**Mandatory
Service Bulletin**

**MAIN ROTOR BLADE ABRASION STRIP
DAILY INSPECTION REQUIREMENTS**

REVISION:

This document supersedes 2100-8R3, and clarifies applicability. This Bulletin is only intended to apply to Abrasion Strips installed new at the HTC Factory or during repair by the HTC Factory. It is not intended to apply to Abrasion Strips installed at Authorized Repair Stations outside of the HTC Factory.

Figure 1 – 1.25 inch (31.8 mm) Chord Abrasion Strip

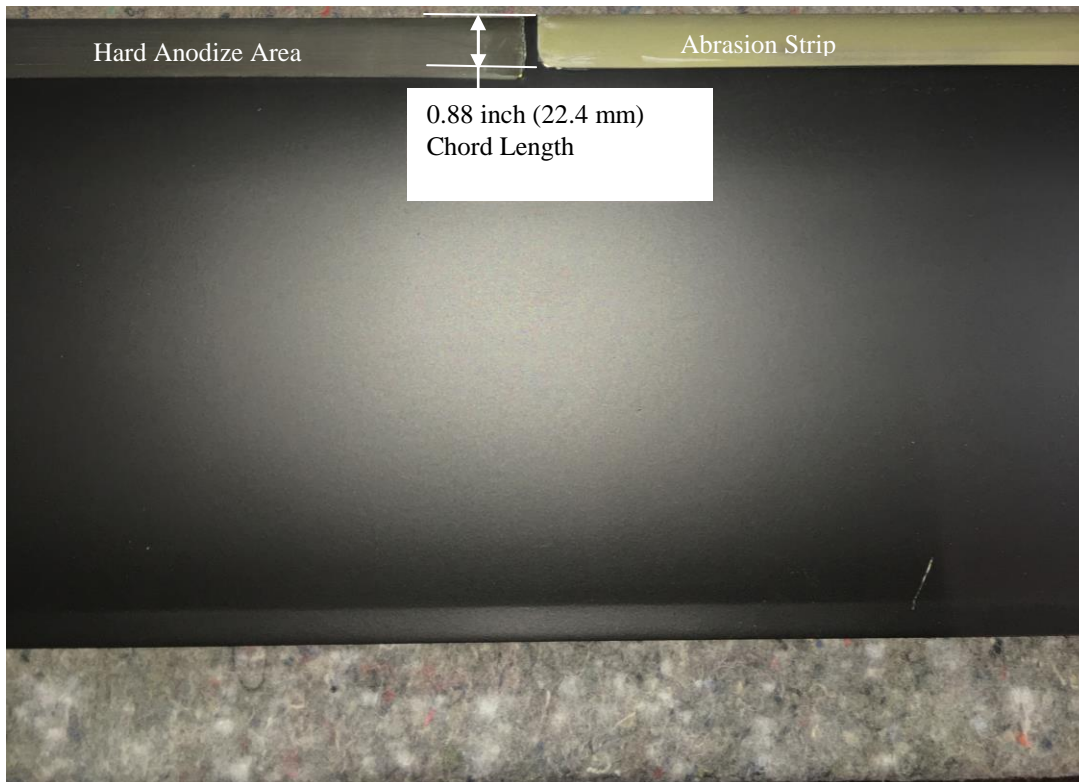
Subject
to this
Mandatory
Service
Bulletin

Subject
to this
Mandatory
Service
Bulletin

Not
Subject
to this
Mandatory
Service
Bulletin

Not
Subject
to this
Mandatory
Service
Bulletin

- 1) Determine which Chord Length Abrasion Strip is present on the subject blade and Total Time Since New (TTSN) or since Abrasion Strip Replacement to determine if this Mandatory Service Bulletin is applicable. Reference **Figure 1** and **Figure 2** on Page 2.

- 1) If applicable, Fielded Main Rotor Blades are to be returned to the HTC Factory or an HTC Authorized Repair Station qualified to perform this modification. This modification consists of the removal and replacement of the Abrasion Strip with a 0.88 inch (22.4 mm) chord Stainless Steel Abrasion Strip in accordance with HTCQ-004, Revision I (or later approved revision) Standard Repair Instruction – Main Rotor Blade. Installation of the 0.88 inch (22.4 mm) chord Stainless Steel Abrasion Strip shall constitute compliance and repeating **PART 1** is no longer required.

Figure 3 – Inboard Abrasion Strip Area

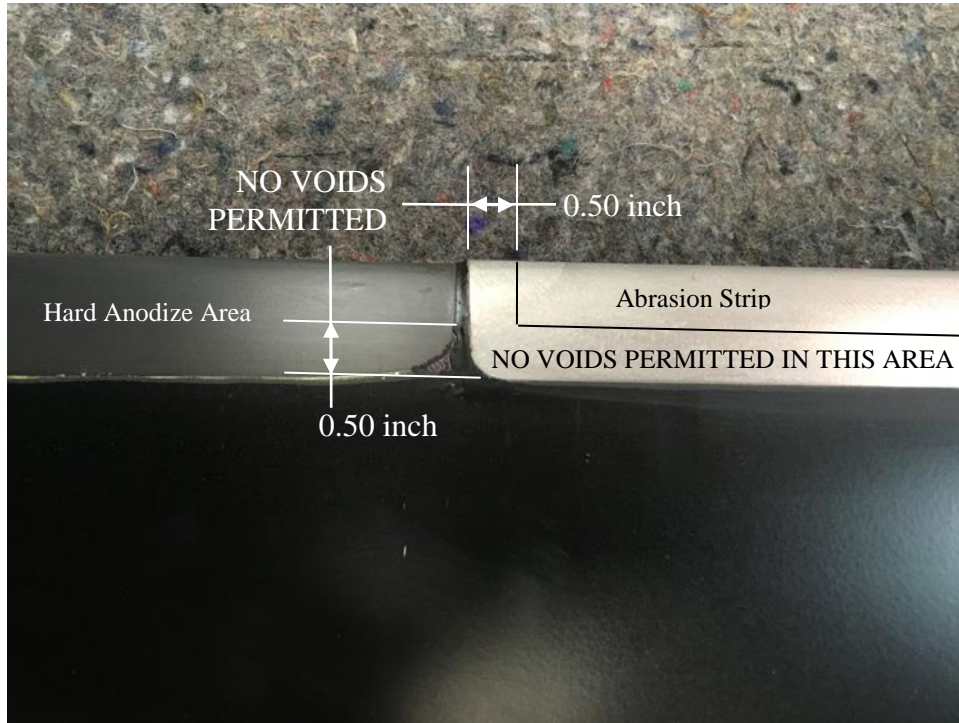
- 5) If any Void is found within 0.50 inches (12.7 mm) of any edge regardless of size, replace the subject blade with another airworthy blade, Reference **Figure 3** and **Figure 4** on Page 5. **Note: Do not attempt a field repair.**
